I, SCOTT M MCGEE, NMPE 10519, OF THE FIRM SCOTT M MCGEE PE, LLC, HEREBY CERTIFY THAT THIS PROJECT HAS BEEN GRADED AND WILL DRAIN IN SUBSTANTIAL COMPLIANCE WITH AND IN ACCORDANCE WITH THE DESIGN INTENT OF THE APPROVED PLAN DATED 11/09/10. THE RECORD INFORMATION EDITED ONTO THE ORIGINAL DESIGN DOCUMENT HAS BEEN OBTAINED BY CHRISTOPHER A MEDINA, NMPS 15702, OF THE FIRM TERRA LAND SURVEYS. I FURTHER CERTIFY THAT I PERSONALLY VISITED THE PROJECT SITE ON 10/14/11 AND HAVE DETERMINED BY VISUAL INSPECTION THAT THE SURVEY DATA PROVIDED IS REPRESENTATIVE OF ACTUAL SITE CONDITIONS AND IS TRUE AND CORRECT TO THE BEST OF MY KNOWLEDGE AND BELIEF. THIS CERTIFICATION IS SUBMITTED IN SUPPORT OF A REQUEST FOR CERTIFICATE OF OCCUPANCY.

CITY OF ALBUQUERQUE PUBLIC WORKS DEPARTMENT ENGINEERING GROUP		SECTION _____												
TITLE: CITY OF ALBUQUERQUE ZOO														
GRADING AND DRAINAGE PLAN														
Design Review Committee	City Engineer Approval

CITY OF ALBUQUERQUE
RIO GRANDE ZOO ENTRY IMPROVEMENTS

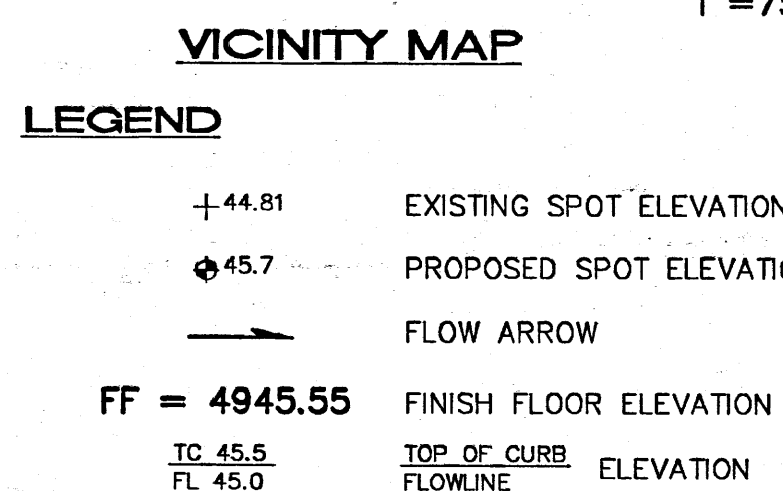
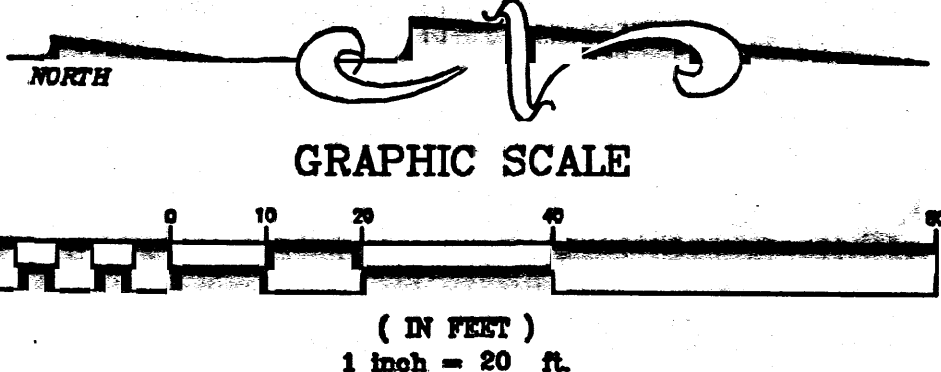
THE PARKING LOT GRADE MODIFICATIONS AND MEDIAN CURB CUTS WERE NOT BUILT. THE PARKING LOT INLETS AND STORM DRAIN LINES WERE NOT BUILT
